Agenda Item 3
410 Oak Knoll Drive
Approval Extension – New Single Family Residence

Subject: **410 Oak Knoll Drive – Request for an Extension of a Prior Approval**

410 Oak Knoll Drive

4 LEFT SIDE ELEVATION

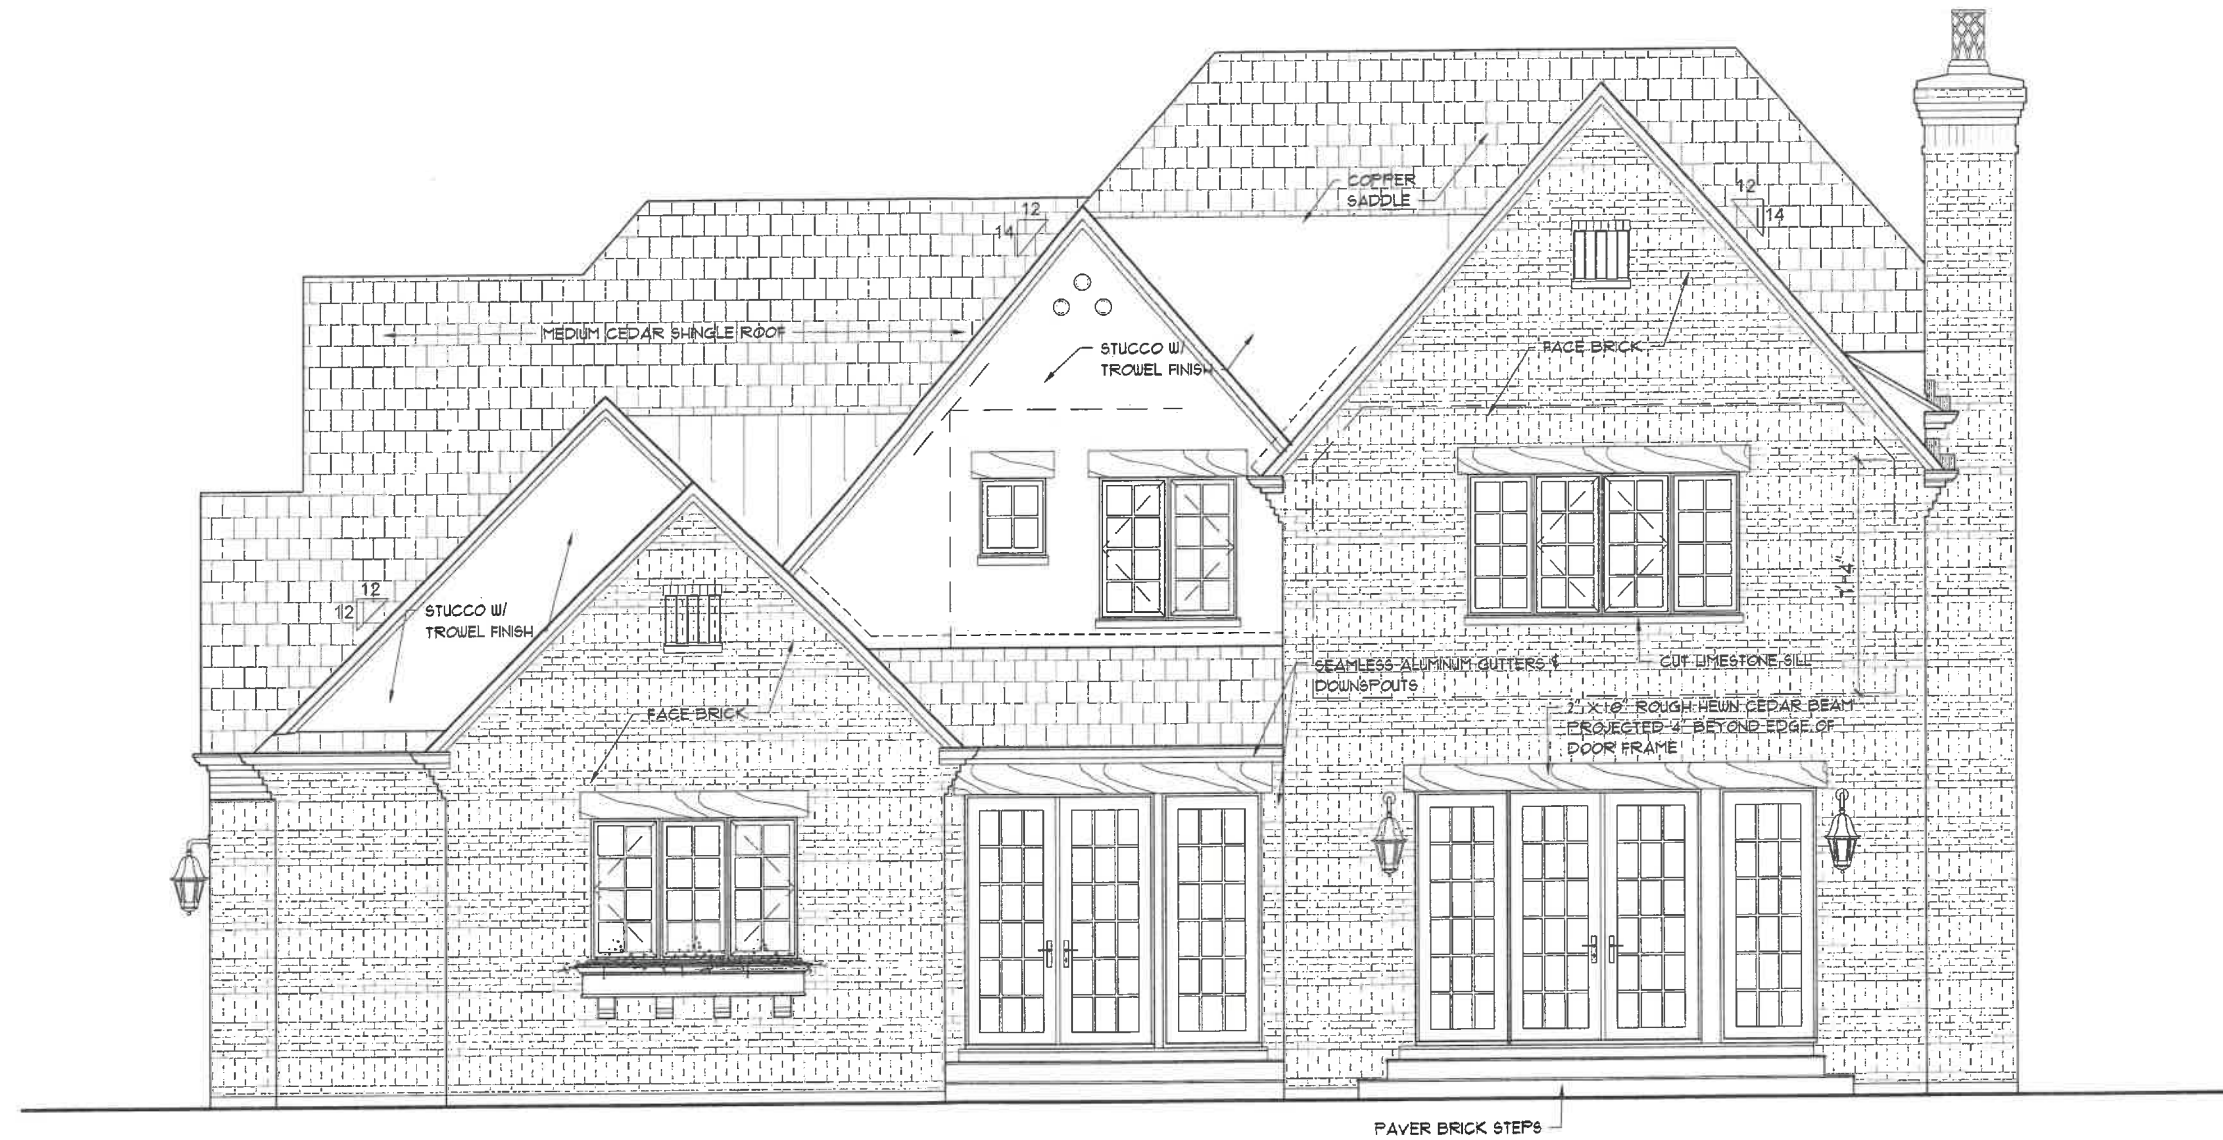
Board member Renken pointed out that the footprint of the home appears to be a square but from a perspective view, the "square" is broken up by the design details including lowering the fascias and adding dormers that project out from the roof and the varying heights. He stated that in his opinion, the design is very successful. He complimented the orientation of the home on an angle noting that the long sweeping roof at the entrance will be visible and the garage hidden. He agreed that the color palette as proposed is historically correct for the chosen architectural style. He suggested that a slight contrast could be considered for the trim color. He stated that the stained wood elements and cedar roof will soften the white brick. He stated support for the petition as presented.

Board member Bluhm complimented the home and stated support for the color scheme. She commented that the Benjamin Moore White Heron color reads a bit more gray than a classic white, which is proposed for the trim, which may create some contrast between the brick and trim color.

1. Aluminum clad wood windows are required.
2. All modifications to the plans including refinements made in response to Board comments or as the result of final design development shall be clearly called out on the plan and a copy of the plan originally provided to the Board shall be attached to the building permit application for comparison purposes. Staff is directed to review any changes to the plans in consultation with the Chairman as appropriate to determine whether the modifications are in conformance with the Board's direction and approval prior to the issuance of any permits.
